Review of Plans: Rockland Homes for Heroes, 335 Western Highway, Tappan, Orangeburg, NY  
Section 74.18 Block 3 Lot 48 R-15 zone  
This matter is scheduled for:

Subject: **Camp Shanks Homes for Hero's Site Plan**  
Prepreliminary/ Preliminary Site Plan,  
Conditional Use Permit and SEQRA Review  
335 Western Highway, Tappan  
74.18/3/48; R-15 zoning district

**PB#19-68: Camp Shanks Homes for Hero's Site Plan      Permit #49045**  
**Preliminary Site Plan Approval Subject**  
**to Conditions/ Neg. Dec.**

**RE:            Camp Shanks – RHFH Phase II Site Plan:** The application of Rockland Homes for Heroes, owner, for Prepreliminary/ Preliminary/ Final Site Plan Review at a site to be known as “**Camp Shanks – RHFH Phase II Site**”, in accordance with Article 16 of the Town Law of the State of New York, the Land Development Regulations of the Town of Orangetown, Chapter 21A of the Code of the Town of Orangetown and to determine the environmental significance of the application pursuant to the requirements of the New York State Environmental Quality Review Act. The site is located at 335 Western Highway, Tappan, Town of Orangetown, Rockland County, New York, and as shown on the Ora

TITLE:  
**PROPOSED GRADING  
 & UTILITY PLAN**

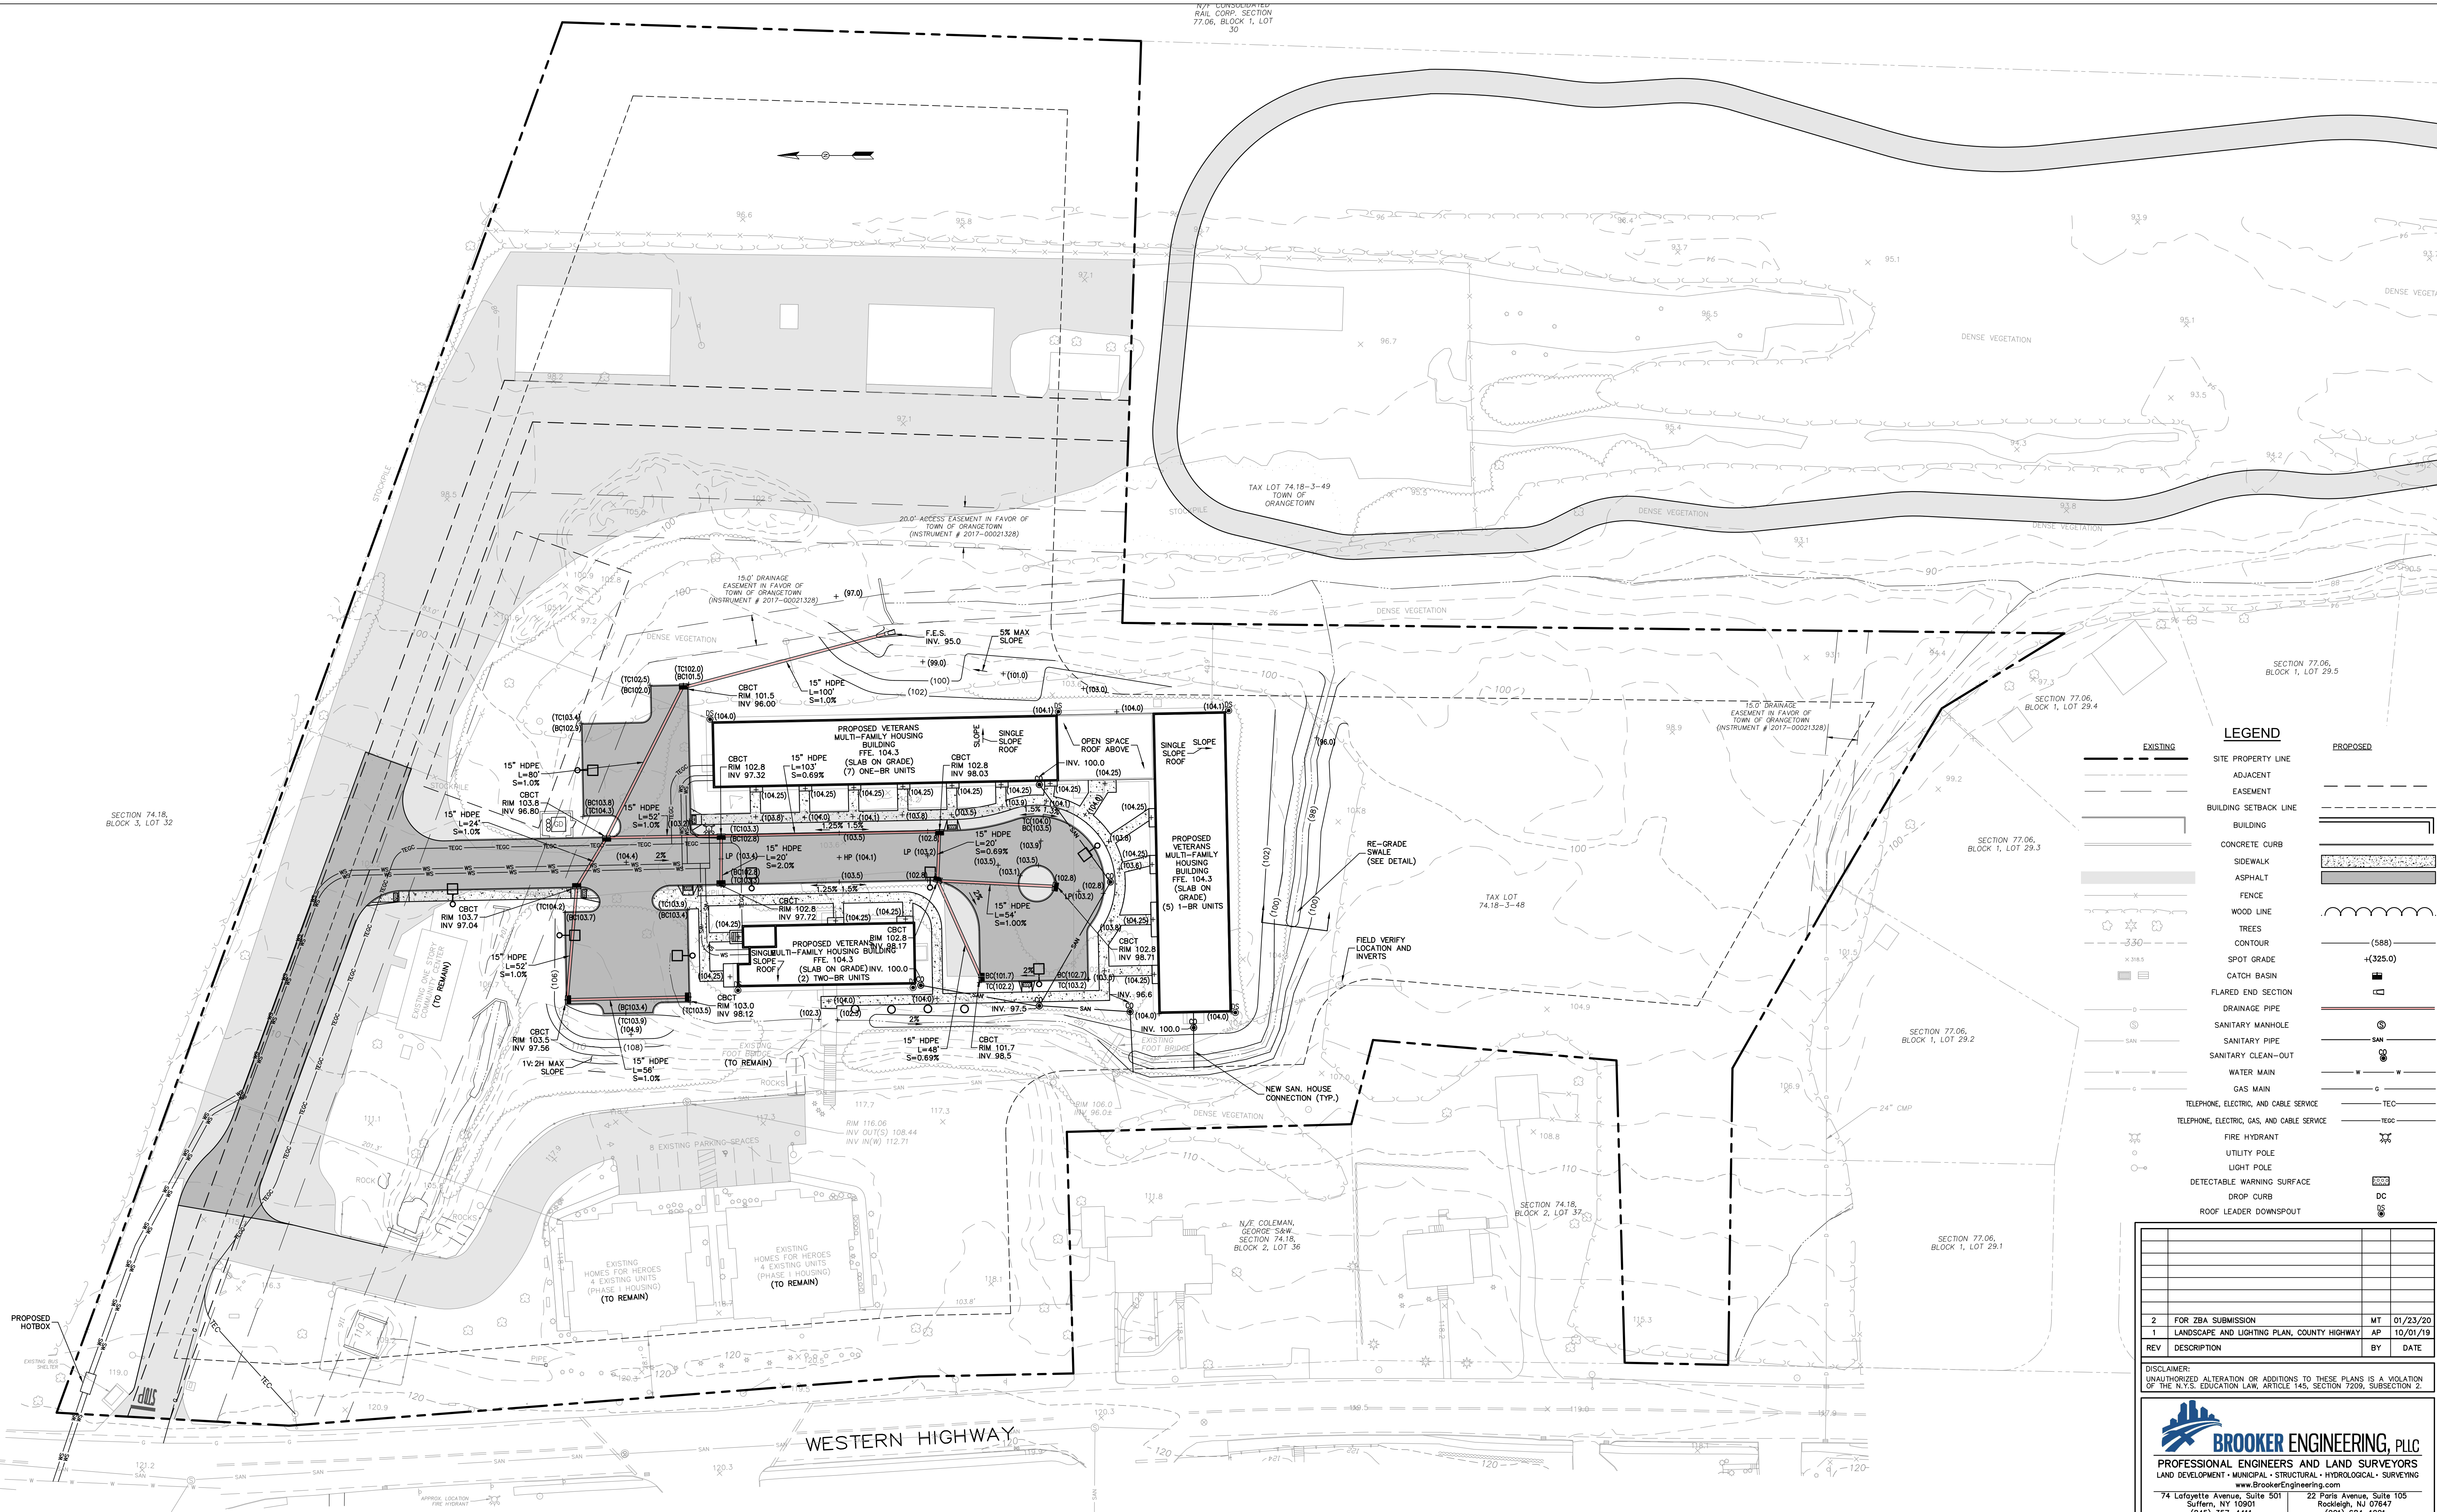
15. The existing sanitary main is only 8 feet off of the southernmost proposed multi-family dwelling. The main is also 8-10 feet deep. This is too close. Given the main's age, there is the real possibility that the Town will need to perform maintenance on it in the future. Having to excavate that deep, near what will be an occupied residence is unacceptable. Therefore, the applicant's engineer shall design a new sanitary main that is further away from the proposed dwelling. Profiles and details for same shall be added to the drawings.

16. Currently, the drawing shows multiple sanitary building connections tying into one line of unspecified size, before connecting to the existing sanitary main. In order for this to be acceptable, the individual building connection must tie into a new 8 inch main or have separate connections from the buildings to the existing main.

21. Profiles for all proposed sanitary and drainage piping shall be added to the plans.

**TITLE:**  
SOIL EROSION & SEDIMENT CONTROL PLAN

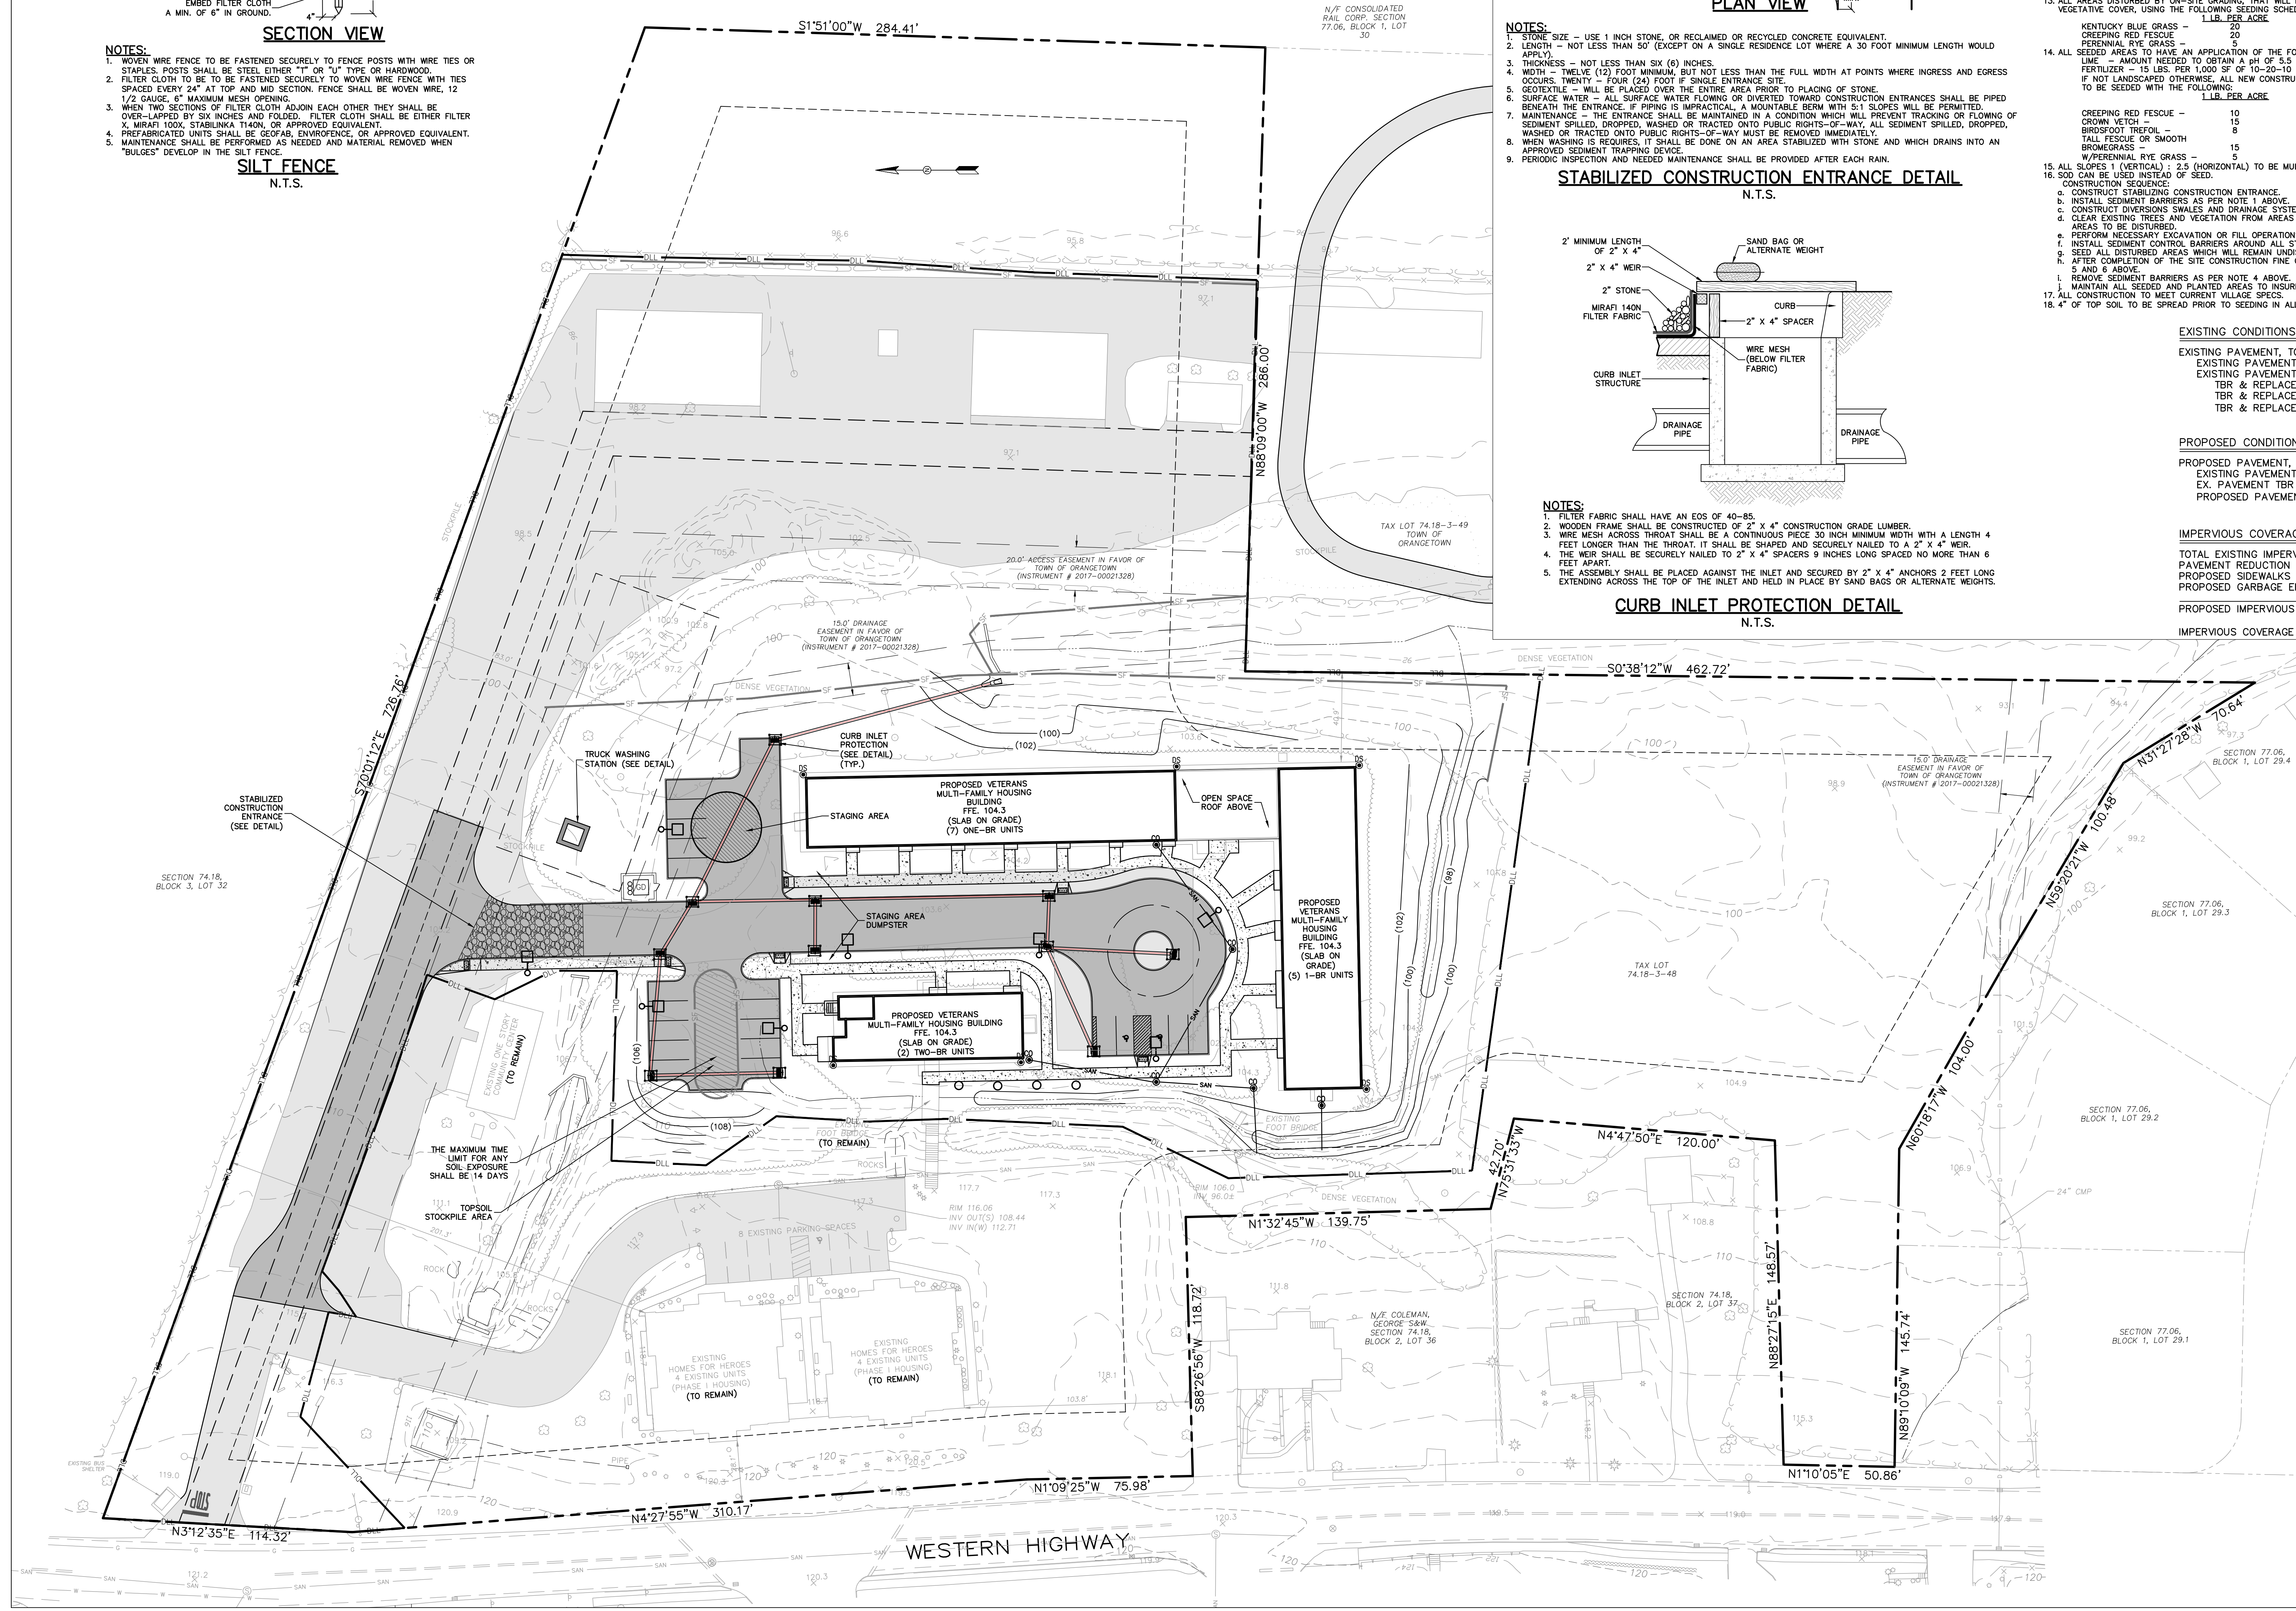
1. According to a note on Drawing 5 of the plans, the site in question is considered a redevelopment activity with an overall reduction in impervious coverage over 25% and therefore post construction water quality and quantity measures are not required. While the Drainage Consultant does not disagree with this approach for drainage on this project, this statement is not entirely accurate, and additional information is required to confirm.

2. Water Quantity controls such as Channel Protection and ten-year and hundred-year criteria would not apply IF the development activities result in no change to the hydrology that increase the discharge rate from the project. Therefore, a pre versus post comparison shall be provided to determine if that is indeed the case for this project.

3. Water Quality treatment objectives can be achieved by the reduction of existing impervious cover by a minimum of 25% of the total disturbed, impervious area. Please elaborate on the breakdown of the impervious surfaces to remain, to be removed, and to be replaced and/ or newly constructed shown in the table provided on Drawing 5. It would be helpful to key them to the areas on the plan so this can be reviewed and confirmed. It is also somewhat confusing in that there is an existing pavement total of 71,266 SF of impervious surface comprised of buildings but it is not clear. In order to claim this reduction, a clear graphic representation on the plans shall be provided, and it shall match the input numbers utilized in the pre versus post comparison requested in comment #2 above.

5. A SWPPP is still required based on the Area of Disturbance being 2.43 acres as indicated on Drawing 5, which is greater than 1 acre.

6. Please show the limit of disturbance graphically on the drawings, as well.
